Meeting Notes

Jefferson County – Courthouse/Sheriff's Building Renovation and Additions

Project No. 2020.01.00 January 11, 2022

Purpose: Discussion to clarify the Scope Of Work for the project.

EXISTING CEILINGS TO BE REMOVED/REPLACED GROUND FLOOR PLAN

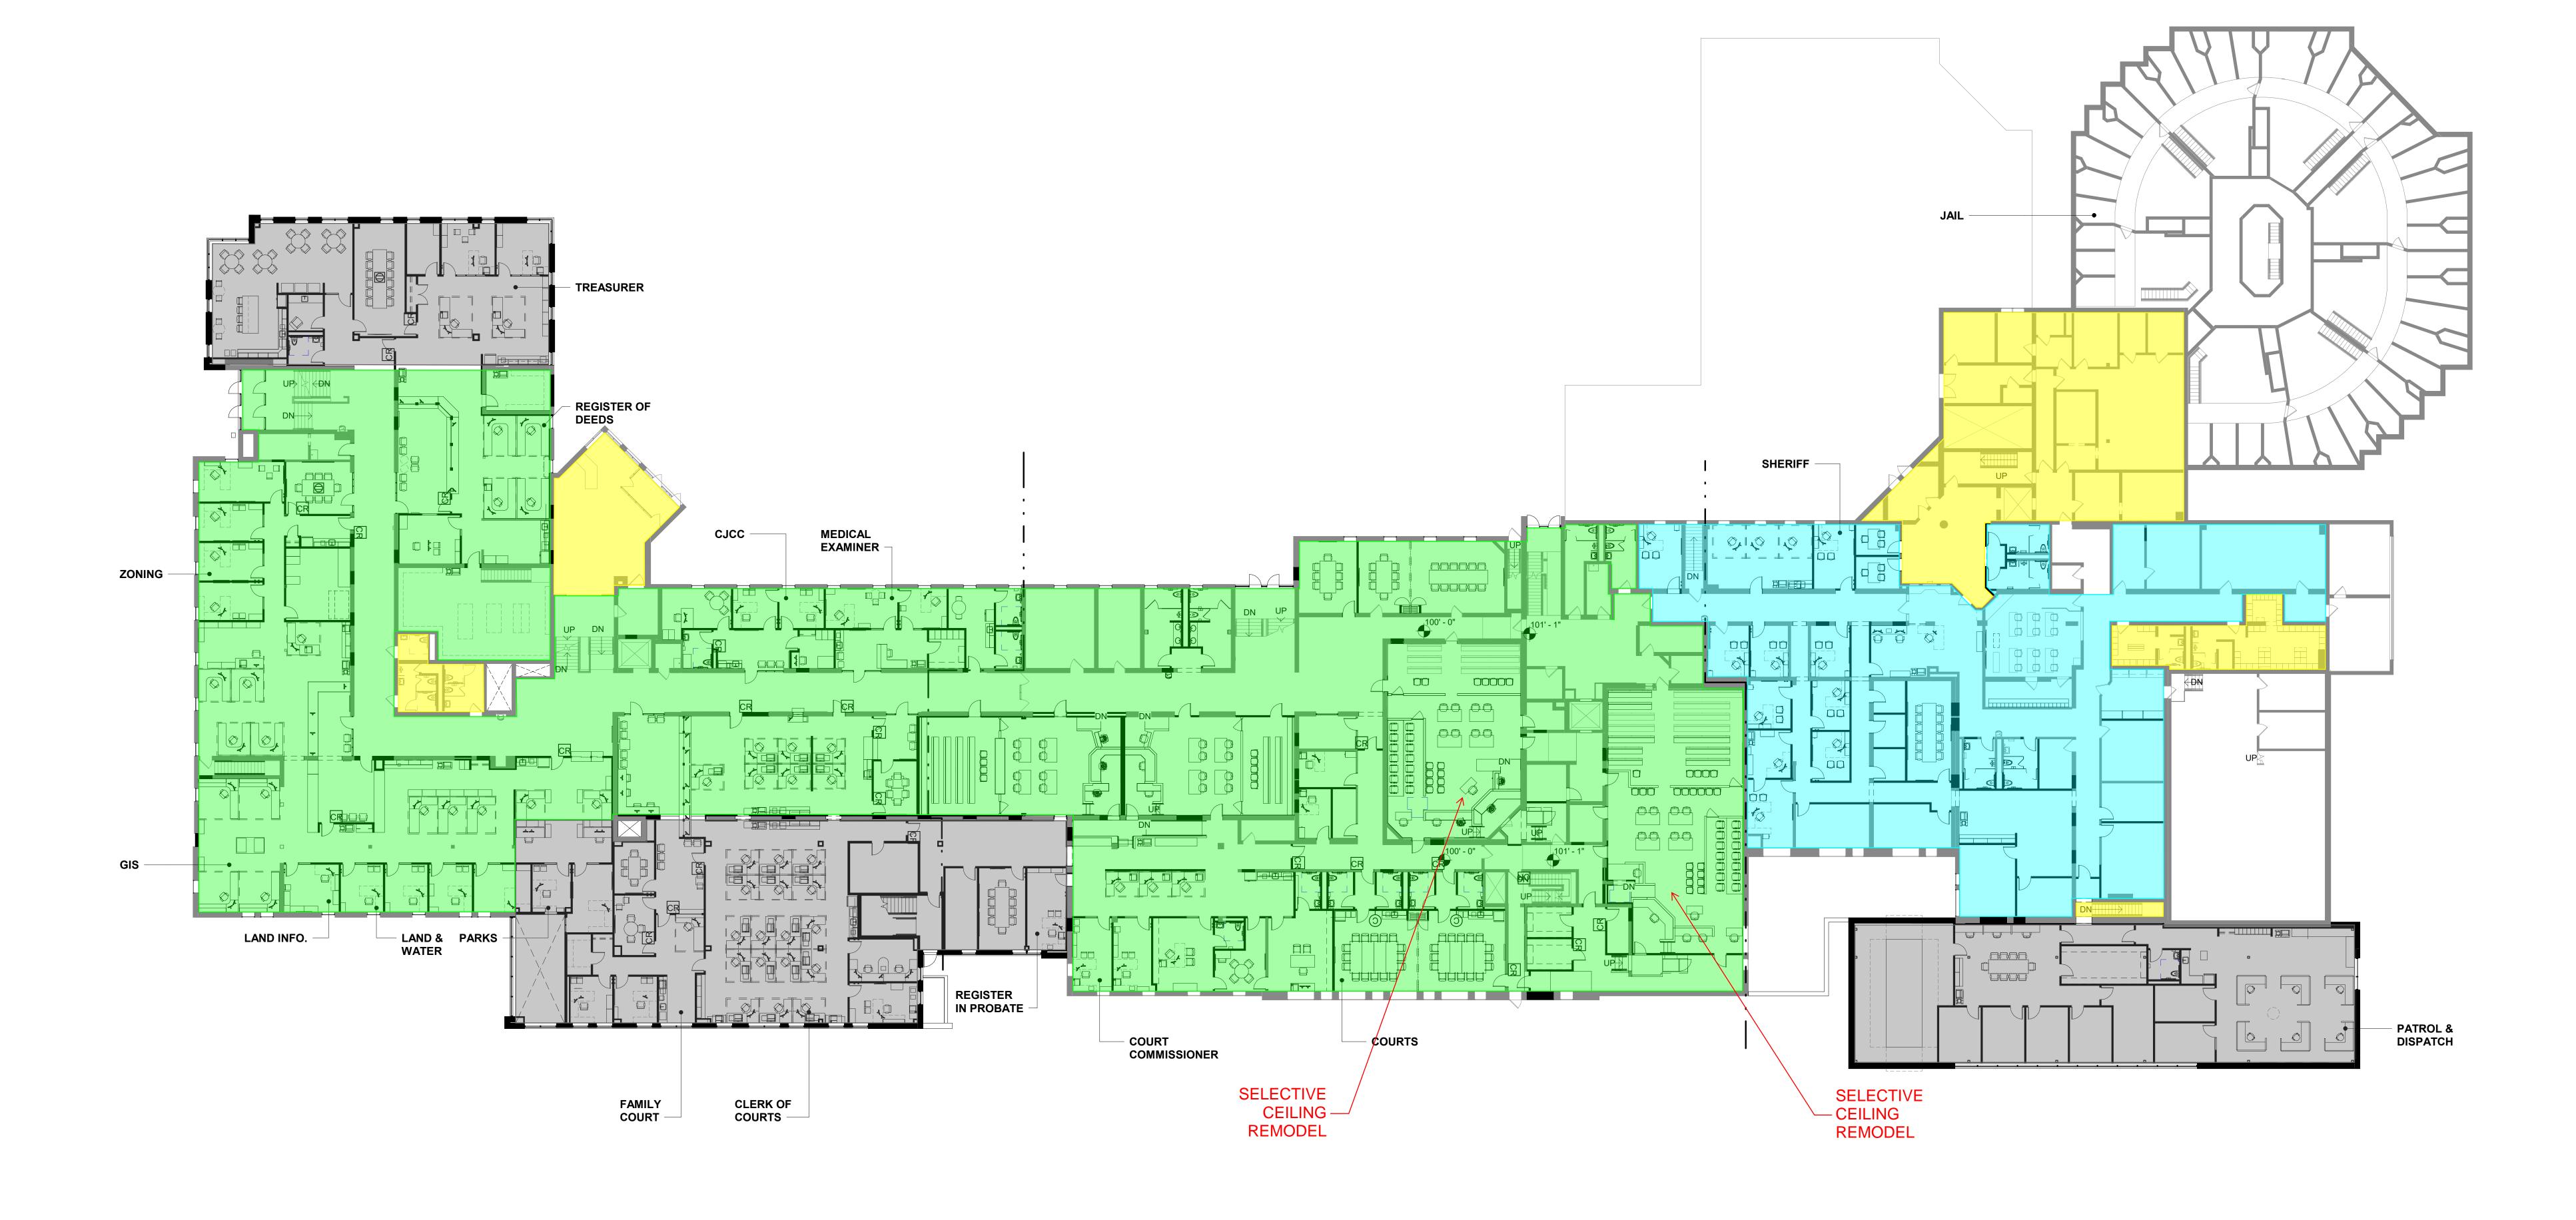
- a. See the attachments for the extent of floor and ceiling removal and replacement.
- 9. Confirm that the programmed space in the lower level of the northeast addition is to be built out at a future time:

EXTENT OF EXPOSED CMU WALLS TO BE FURRED OUT WITH GWB.

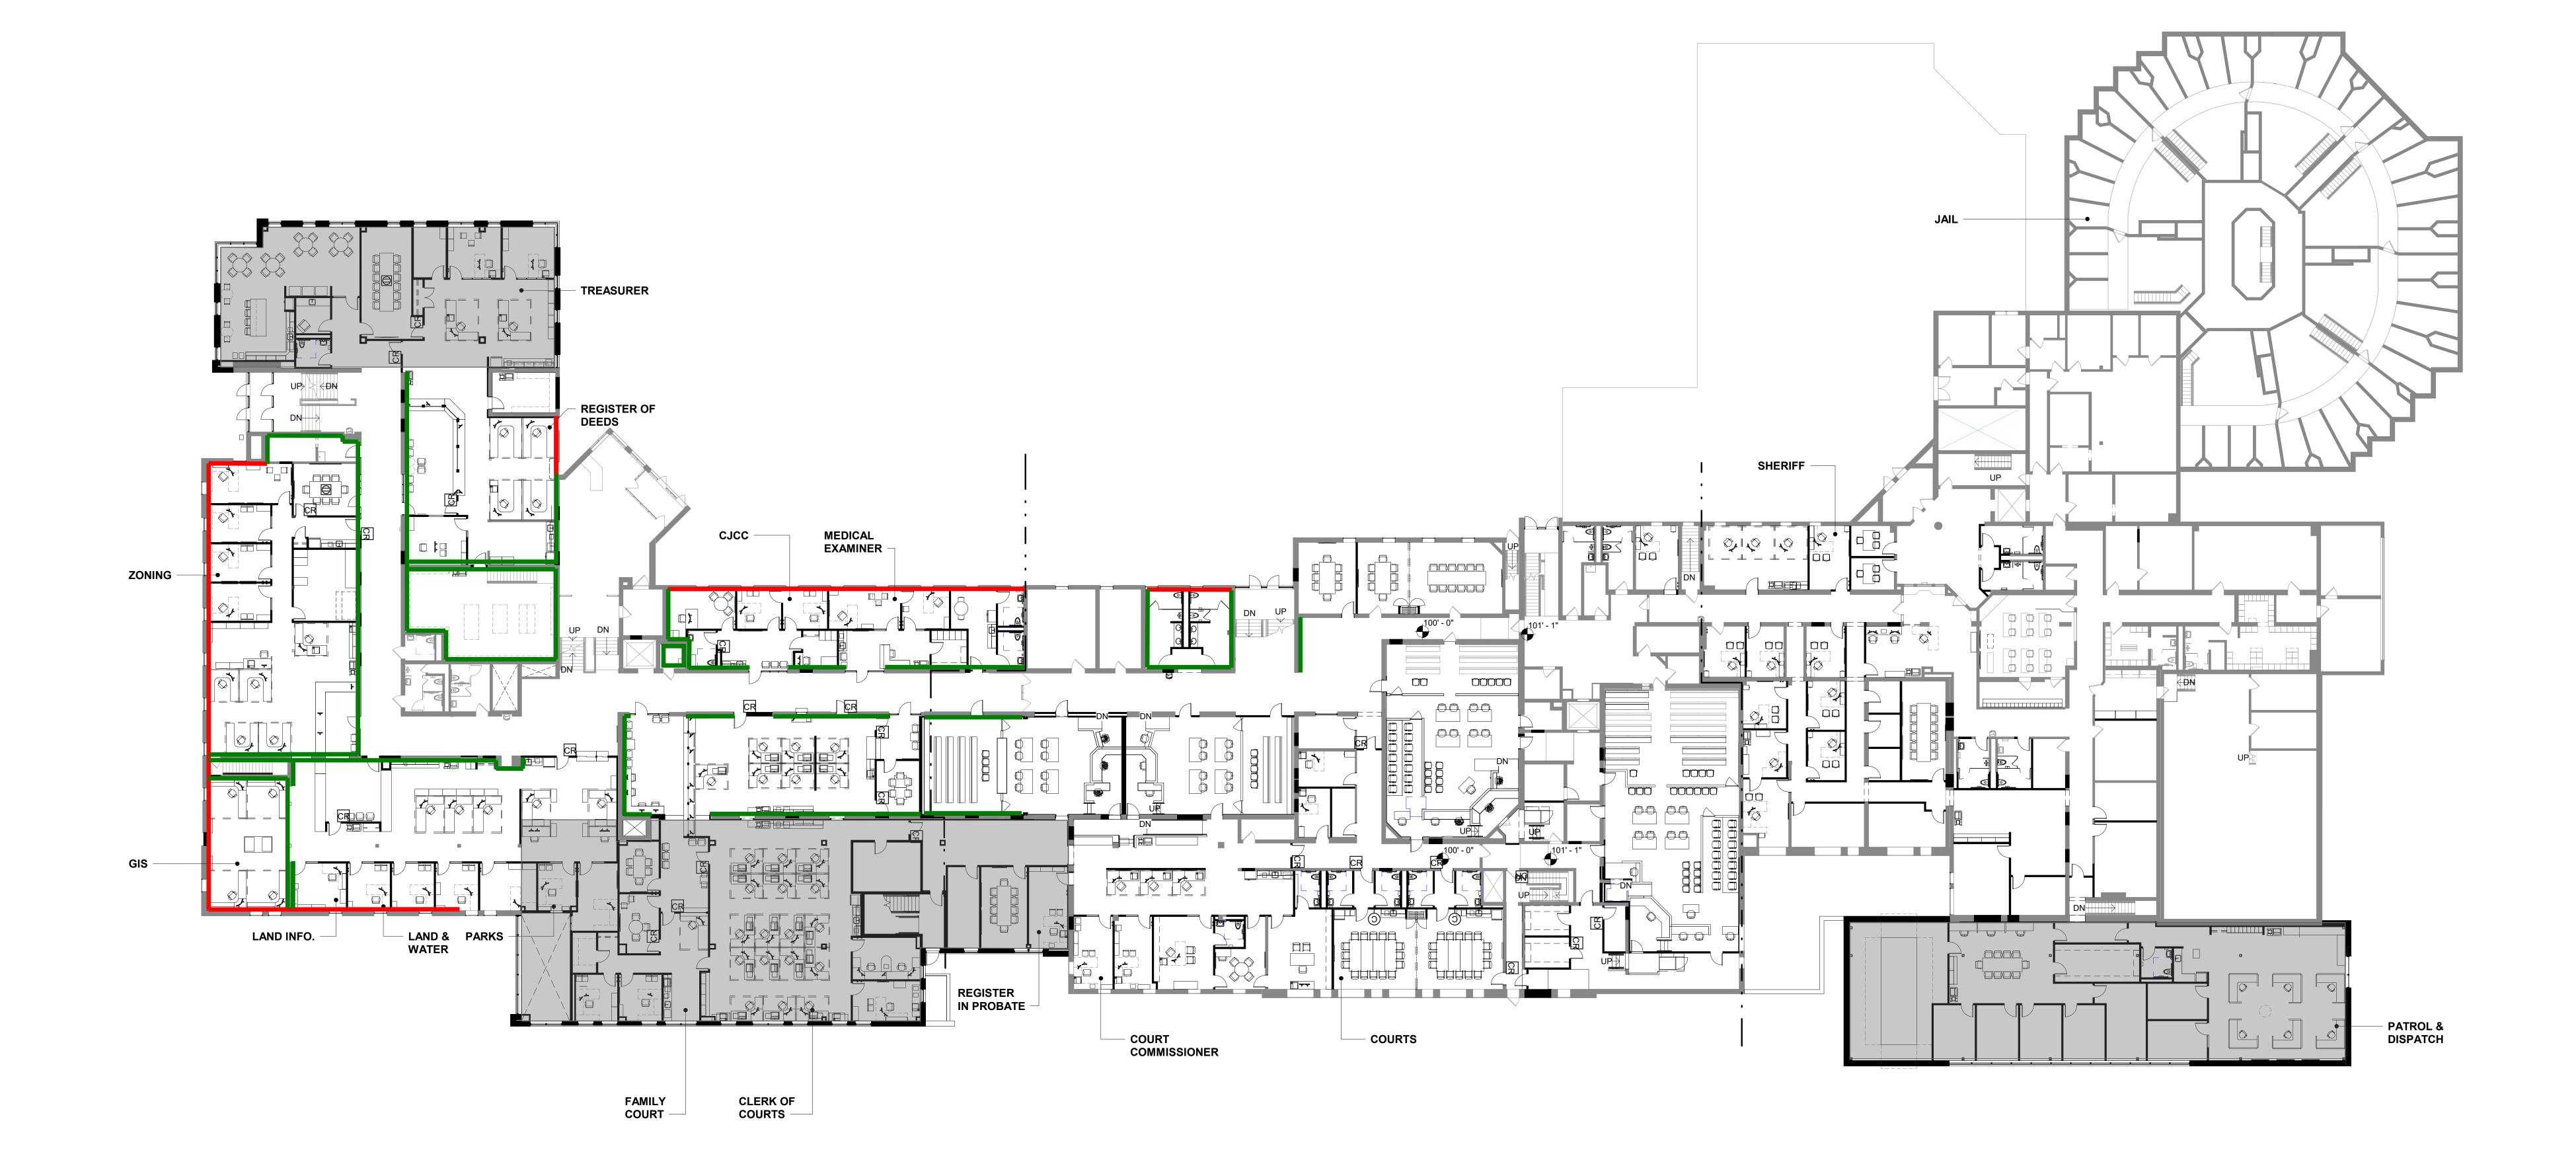
- a. See the attachment for the extent of CMU walls to be furred out with GWB.
- b. PLI will calculate the linear feet of proposed furred out gwb walls.

- c. Maas Brothers will provide an estimated cost for materials and installation of the gwb.
- d. Jefferson County will determine the extent of furred out walls for the project.

- e. GWB will extend 4" above the proposed ceilings.
- f. 2 1/2 " metal studs for furring.
- g. Ben W. stated that the priority would be to fur out the interior walls if a budget decision needs to be made.

- h. Windows and window sills are to be replaced at the exterior walls if furred out.
- i. Furring out the CMU walls of the Hearing Rooms is to be included in the project scope.

TOILET ROOM - SCOPE GROUND FLOOR PLAN

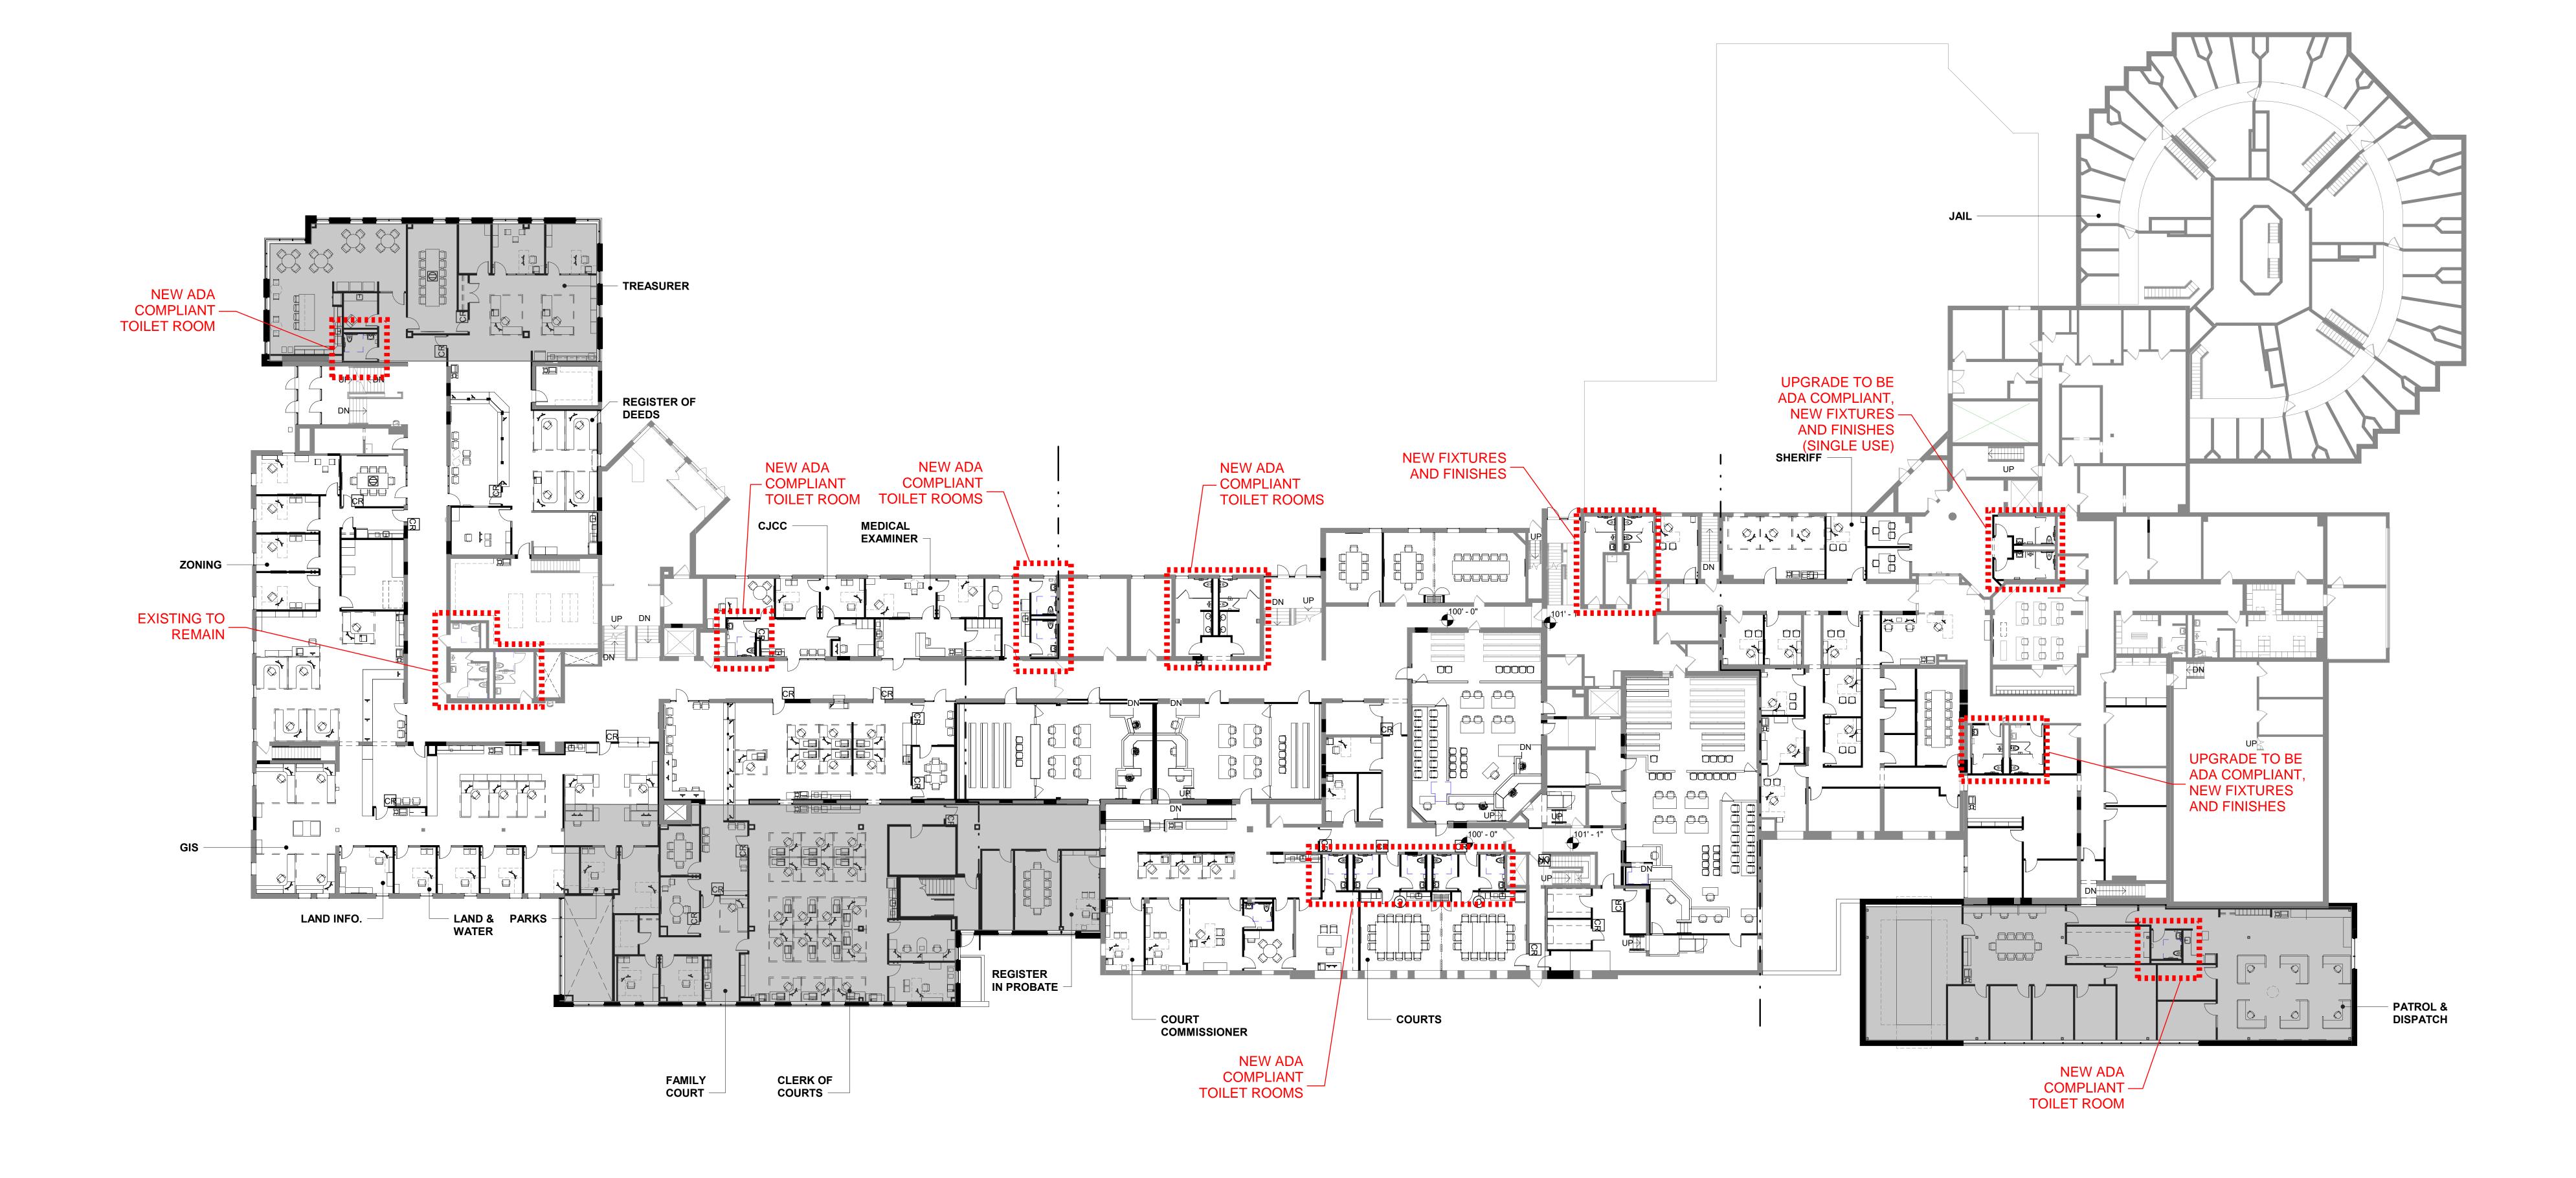
- a. See the attachment for the toilet room scope of work.
- b. If an existing non-ADA compliant toilet room is to remain, signage will need to be provided to direct the public to the nearest ADA compliant toilet room.
- 8. Define the extent of new finishes in the "untouched" spaces:
